M. V. "LEON I" ABS ID 8244775
 EX "LAKE ONEIDA"
 184.85 X 24.41 X 15.08 M
 STOCZNIA SZCZECINSKA S. A., HULL NO B-517/4
 CRANE INSTALLATION, SWL = 25 TONS
 LIFTING APPLIANCE CERTIFICATION
 STABILITY REQUIREMENTS

SUBJECT: Bulk Carrier – Maltese Flag
 M/V “LEON P” – ABSID:8244775
 Ex name: “LAKE ONEIDA”
 185.0 x 24.4 x 15.5 m
 Stocznia Szczecinska S.A., Poland – Hull no. B-517/4
Crane Installation–Review of Electrical Plans (Load Analysis and Main Switchboard Single Line Diagram)

SUBJECT: Bulk Carrier
M. V. "LEON 1" ID 8244775
Ex "LAKE ONEIDA"
185.00 x 24.40 x 15.50 m
Stocznia Szczecinska S. A
Installation of Pedestals
Lifting Appliance Certification

INSTALLATION OF 4 PEDESTAL CRANES

No. MA-038-IA. "Construction Plan of Cranes Fitting", dated October 1999

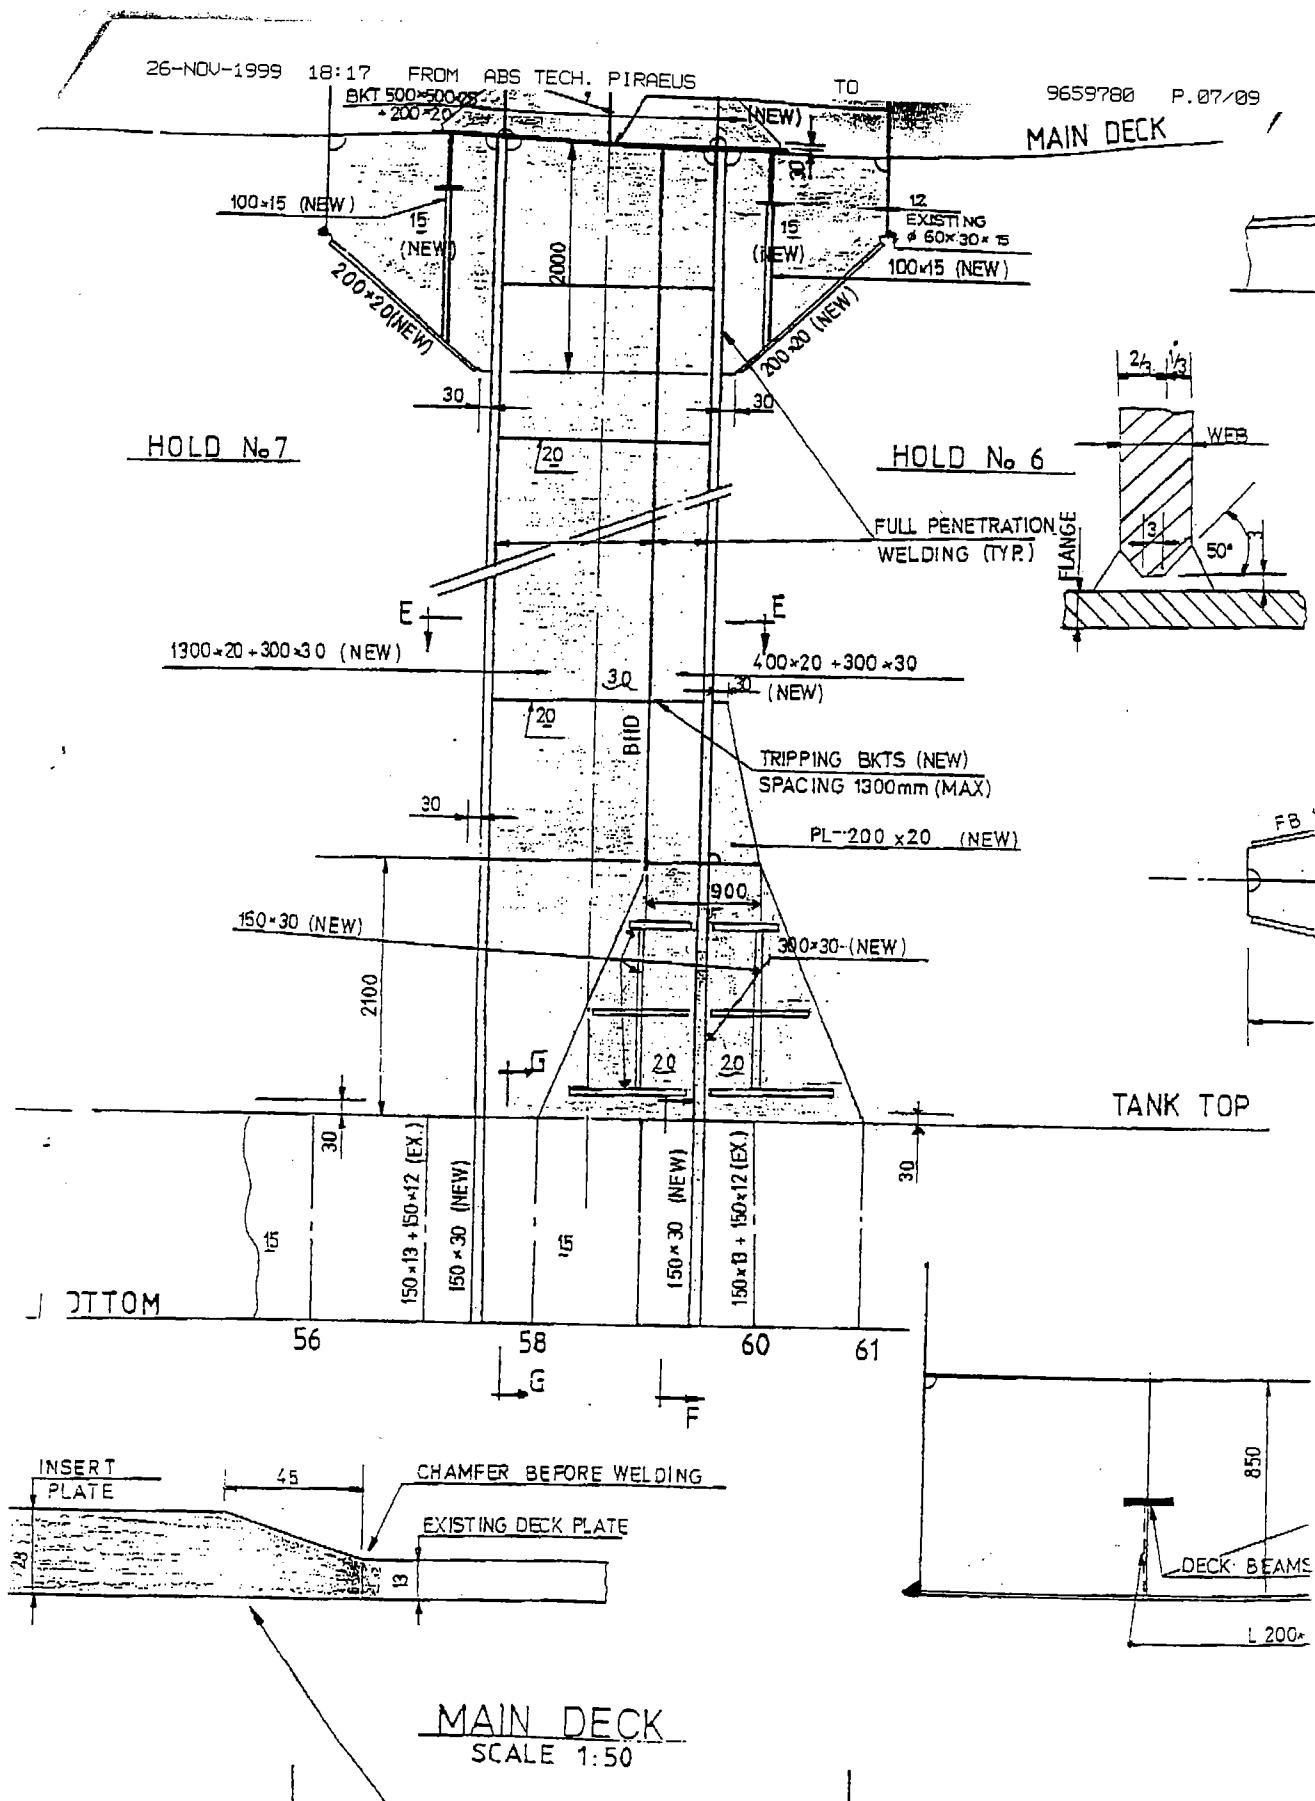
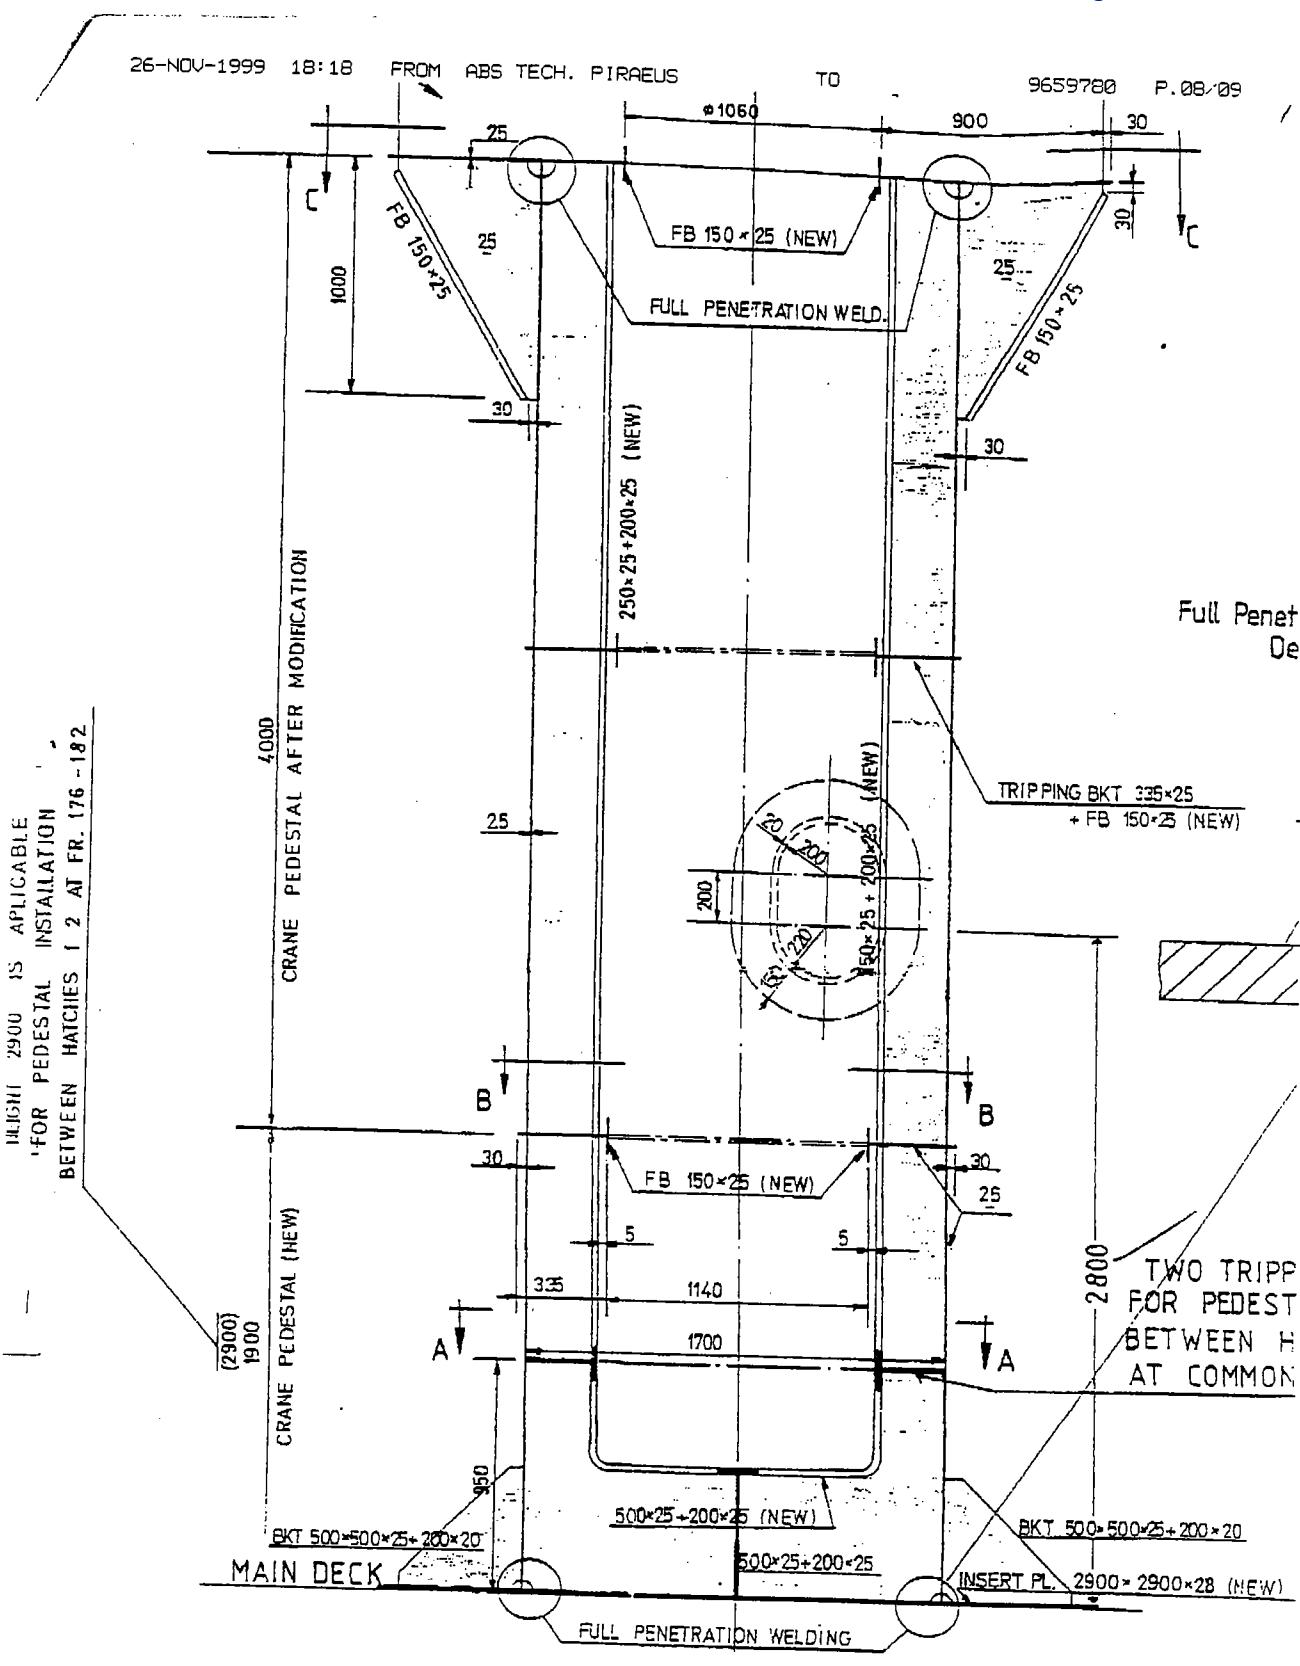
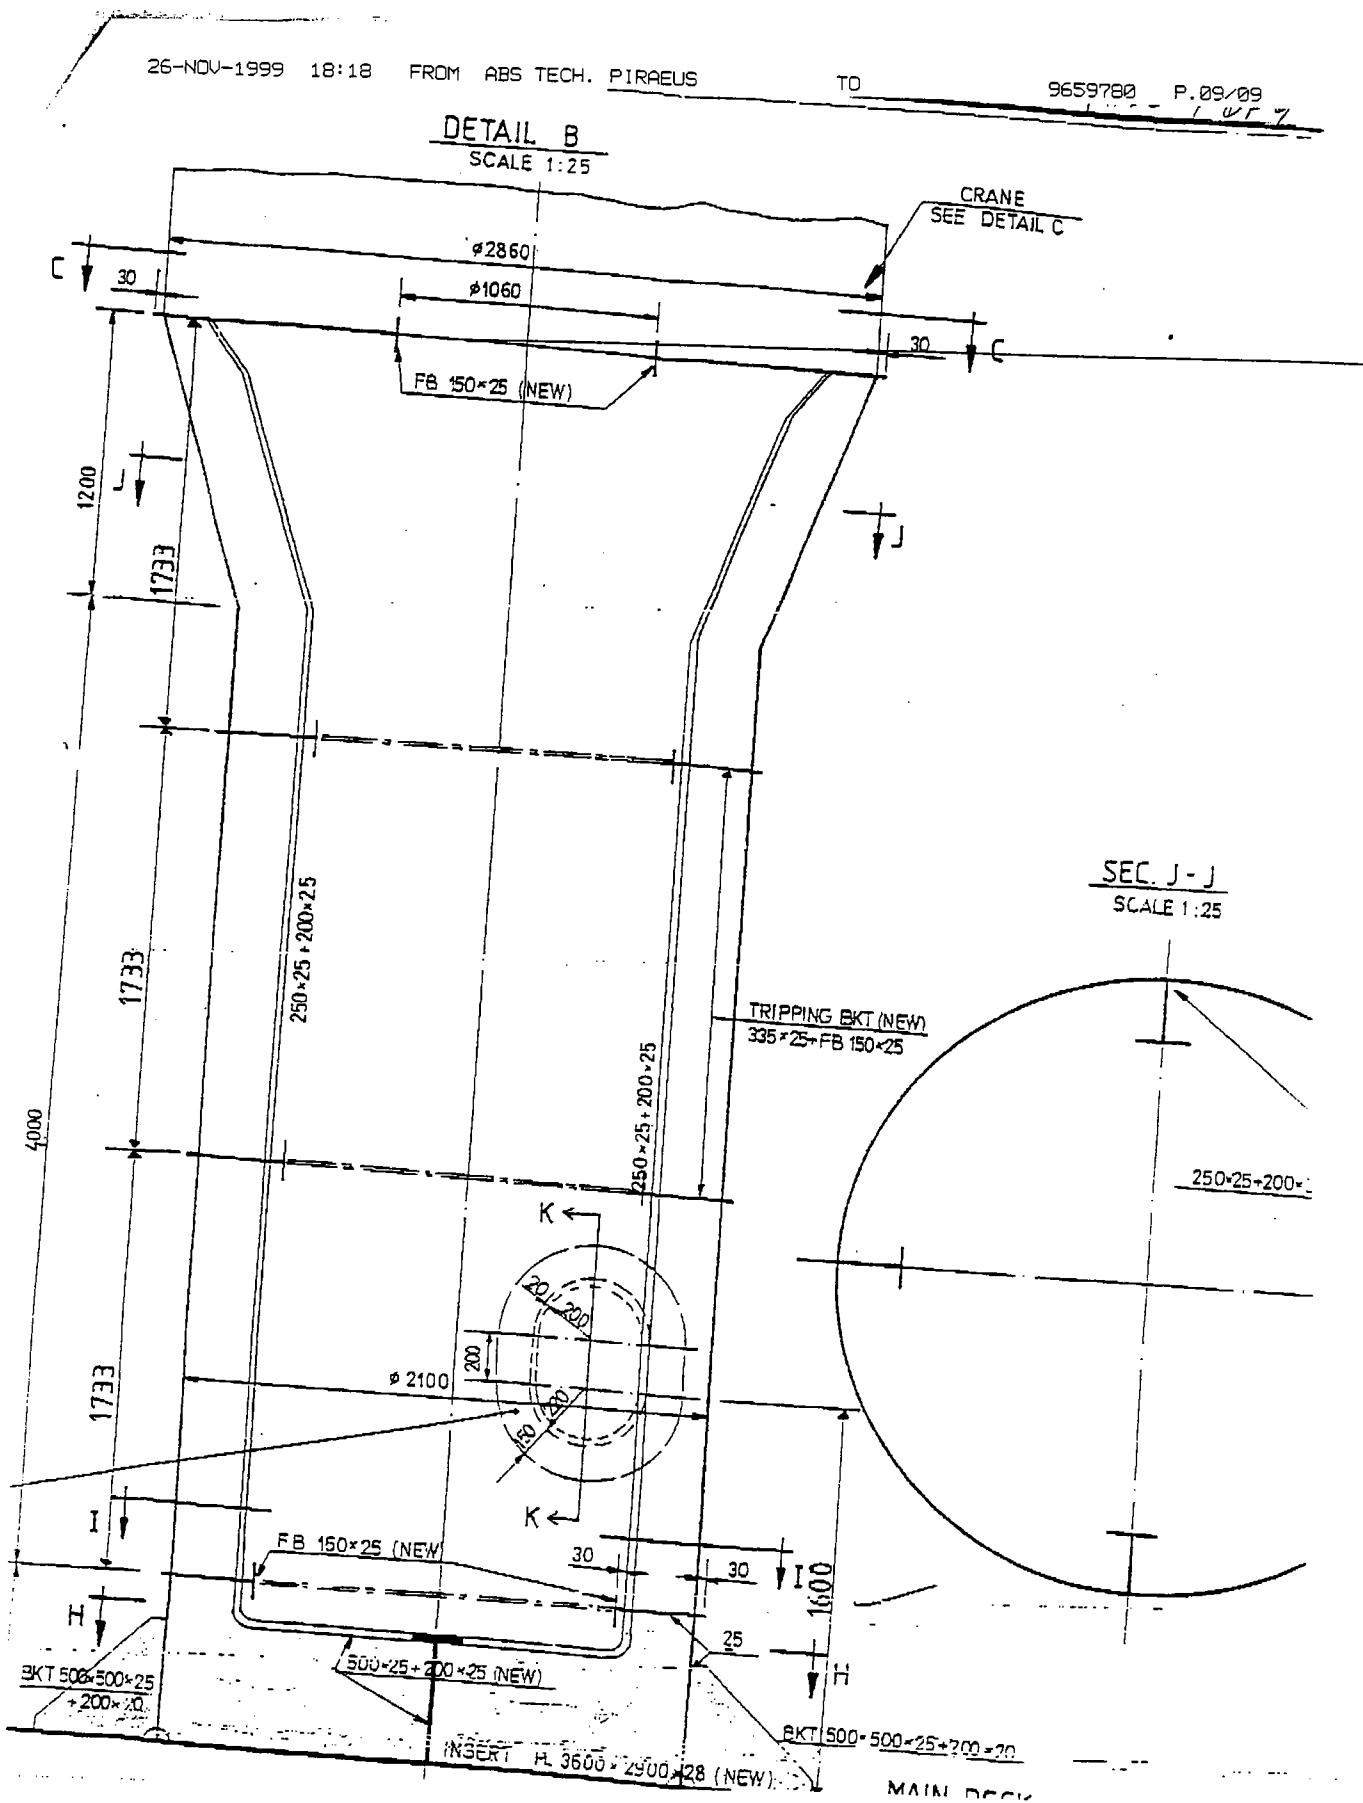
FINAL REVISED DRAWING NO: MA-038-IA, "CONSTRUCTION PLAN OF CRANES FITTING", DATED OCTOBER 1999, HAS BEEN APPROVED BY OUR LETTER OF 25 NOVEMBER 1999. COPY OF THIS LETTER HAS ALREADY BEEN FAXED TO YOUR OFFICE. ATTACHED PLEASE FIND ADDITIONAL COPY OF SAME LETTER. THIS REVISED DRAWING INDICATES THE INCREASE OF PEDESTAL HEIGHT BY ONE (1) METER FOR THE REVOLVING CRANE LOCATED BETWEEN NOS 1 & 2 CARGO HOLD HATCH SATISFYING THE DAMAGE STABILITY REQUIREMENTS. THIS DRAWING HAS ALREADY FORWARDED TO YOUR OFFICE BY COURIER. ATTACHED PLEASE FIND COPIES OF PORTION OF THE ABOVE DRAWING REFLECTING OUR LATEST AMENDMENTS.

Please be advised that the cross deck area, in way of hatch side girder, is reserved pending submission of structural details, frame Nos: 56-61 and 125-132, port or stbd.

U N I T H I G H 2900 IS A P P L I C A B L E
FOR PEDESTAL INSTALLATION
BETWEEN HATCHES 1 2 AT FR. 176 - 182

for the subject lifting appliance. This drawing was resubmitted for approval of alterations made since the previous submission. See ABS letters dated 26 October and 17 November 1999. The revised arrangements and details as indicated are satisfactory. Accordingly three (3) prints of each drawing are being returned, approved for compliance with our requirements for the issuance of an American Bureau of Shipping Register of Lifting Appliances.
